# Technical Bulletin

Bulletin No: TCH-003-046

## Subject: **Bendix® QR-1C™ Quick Release and Double Check Valve Cap Nut**

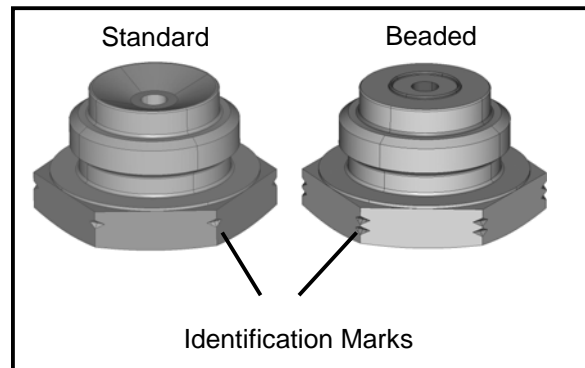
Bendix® Commercial Vehicle Systems LLC is offering a "beaded" cap nut for QR-1C valves to enhance the double check valve's ability to seal at low differential pressures. The beaded cap nut is an enhancement to parking systems that use a QR-1C valve.

The new beaded cap nut is available in QR-1C valve assemblies or through a retrofit kit. Even though the beaded cap nut is interchangeable, Bendix recommends that the vehicle manufacturer be consulted before changing the cap nut of the QR-1C.
